Appendix II-E
Form 2 Packages

CU Certification of Completion

CU BACKFILL/ENGINEERED CAP COMPLETION APPROVAL - FORM 2						
Reporting Date	11/24/2009	Placement Start Date			10/28/2009	
CU Number	1	Placement End Date			11/20/2009	
Approximate CU Centroid	Northing	1616824.789	Easting	735165.184	NY State NAD 83	
CU Size	3.39	Acres				
Backfill Area	0	Acres				
Cap Area	3.39	Acres				
Backfill Surface Mean Tri+ PCBs Concentration (when required)		NA		mg/kg		
Number of nodes sampled		NA		mg/kg		
Backfill NA	Type of Backfill NONE	Reference to appropriate drawings attached to Approval Form 1				
Cap X	Type of Cap Type "B" Medium Velocity Cap Type "B" High Velocity Cap	Reference to appropriate drawings attached to Approval Form 1 CU1 Backfill and Cap Plan, 11/4/09				
CU Checklist		Indicate one of the following			Reviewer Initial Acceptance

Narrative Summary of Backfill and Capping and EPA Backfill and Capping Agreements

- NOTES:**
1. BACKFILL TO BE PLACED IN ACCORDANCE WITH SECTION 13720 AND DESIGN DRAWINGS B-0021-SK1 AND B-0020-SK1.
 2. CAP MATERIALS TO BE PLACED IN ACCORDANCE WITH SECTION 13720 AND DESIGN DRAWING C-0038.

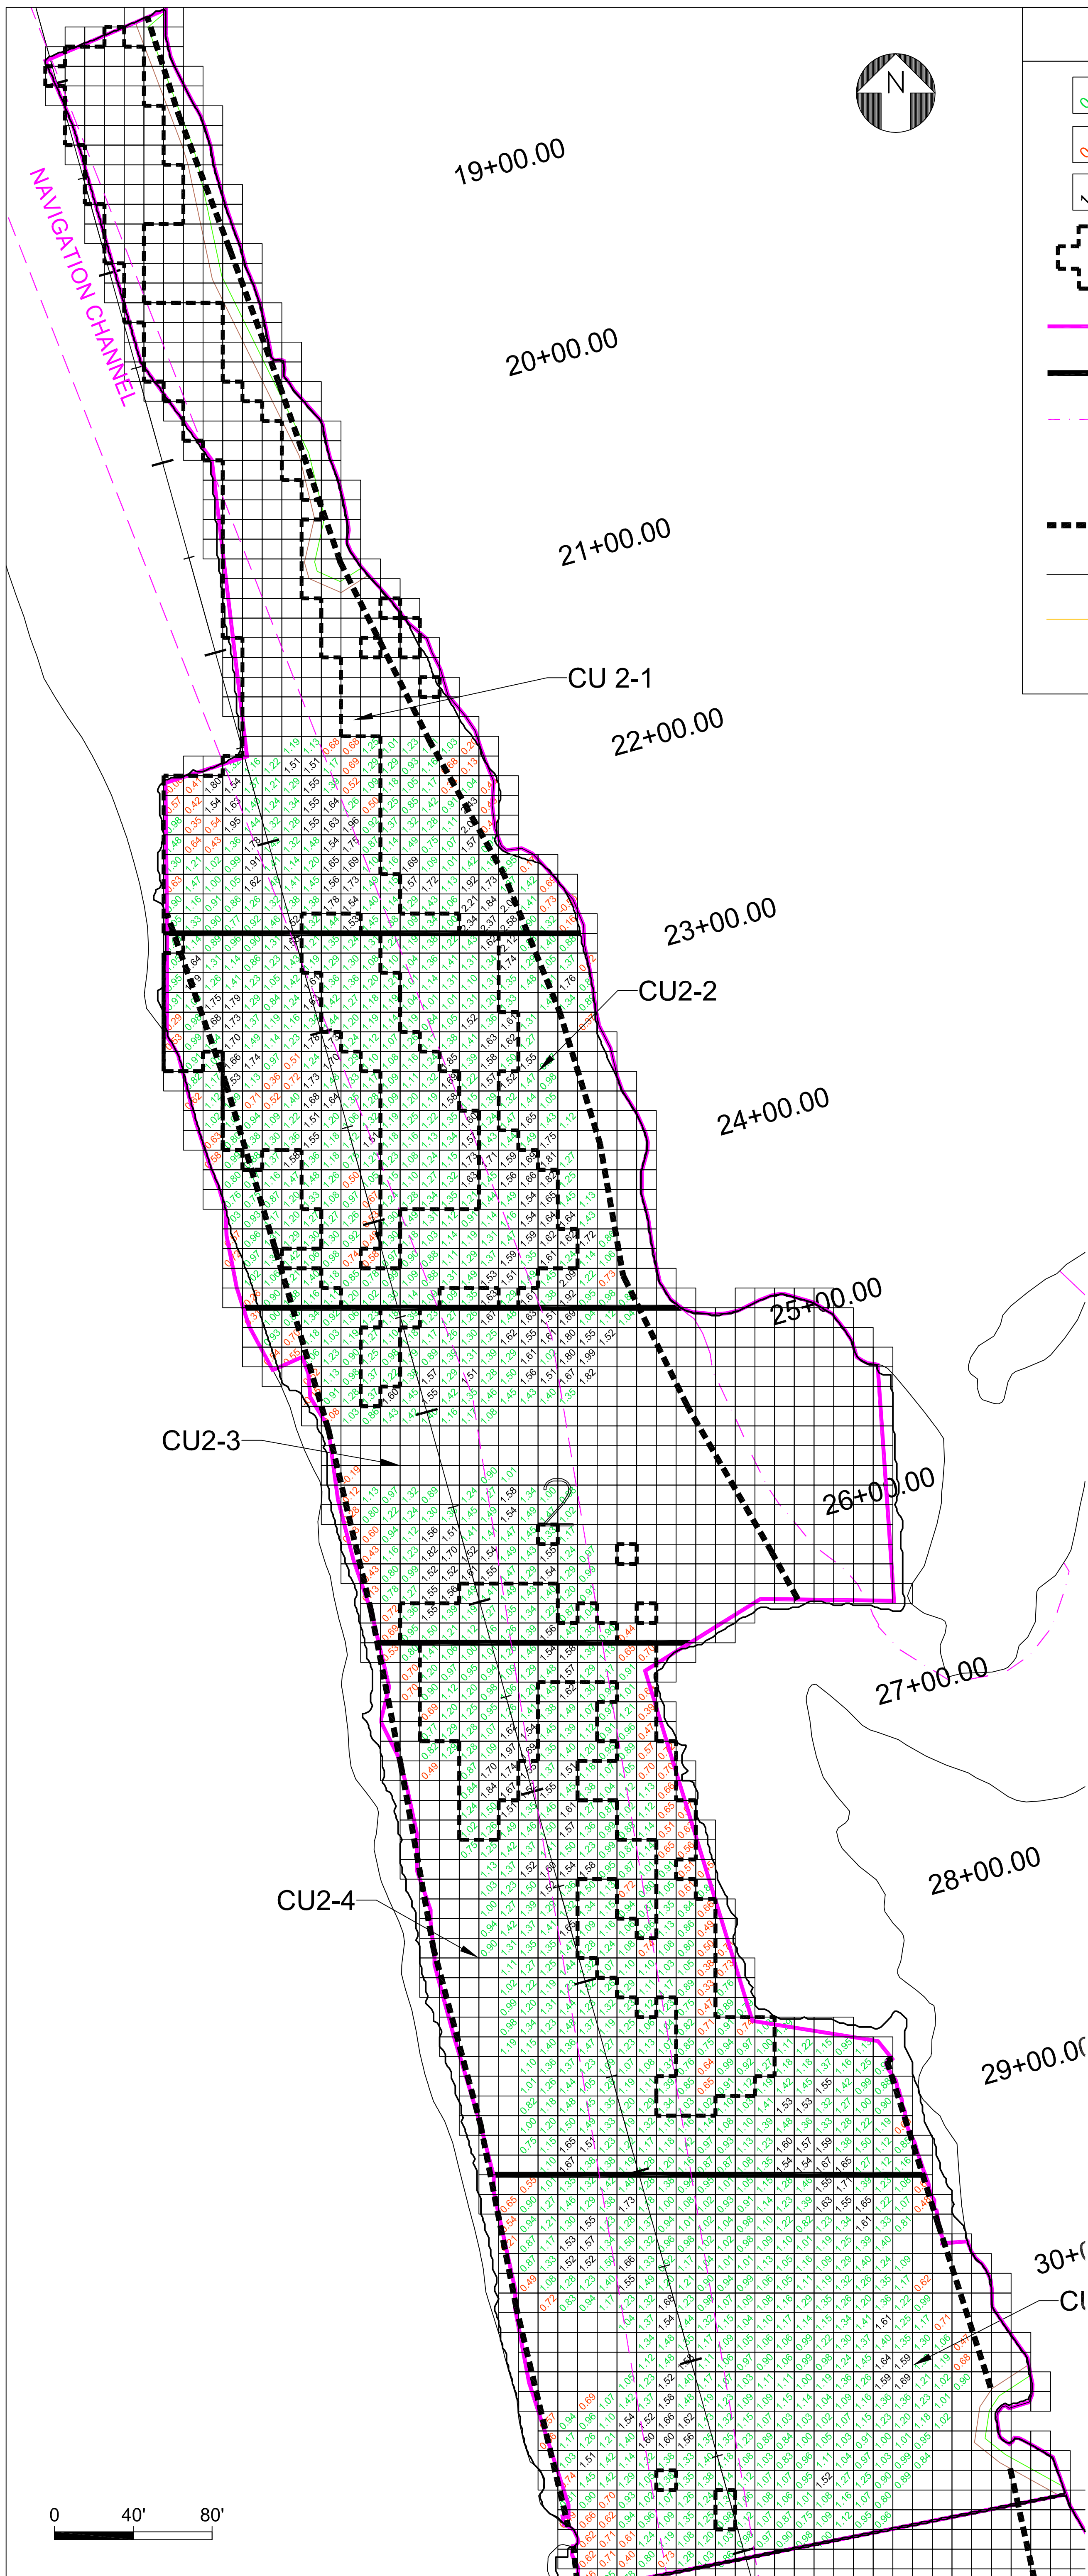
3. ~~CANDIDATE FOR 15% BACKFILL PLACEMENT, PENDING ORDER OF PRIORITY OF OTHER CUs.~~ 15% BACKFILL NOT PLACED, PER EPA DISCUSSIONS.
 4. 1' THICK PLACEMENT OF BACKFILL IN NAVIGATION CHANNEL, BUT NOT TO EXCEED ELEVATION 103'. NO BACKFILL WILL BE PLACED IN THE NAVIGATION CHANNEL UNLESS THE BOTTOM SURFACE OF THE NAVIGATION CHANNEL IS 102.0' OR DEEPER AFTER DREDGING.

6. REPAIR ANY DISTURBANCE TO SHORELINE AREAS GREATER THAN ELEVATION 119' IN ACCORDANCE WITH DRAWING B-0023.
 7. TYPE 2 BACKFILL TO BE PLACED IN LIEU OF TYPE 1 BACKFILL, AS AGREED BY EPA AT OCTOBER 10, 2009 DATA MEETING.

8. THIS AREA IS OVER ROCK AND PER AGREEMENT WITH EPA 12" OF TYPE 2 MATERIAL WAS PLACED, BUT USUAL TOLERANCES DO NOT APPLY.
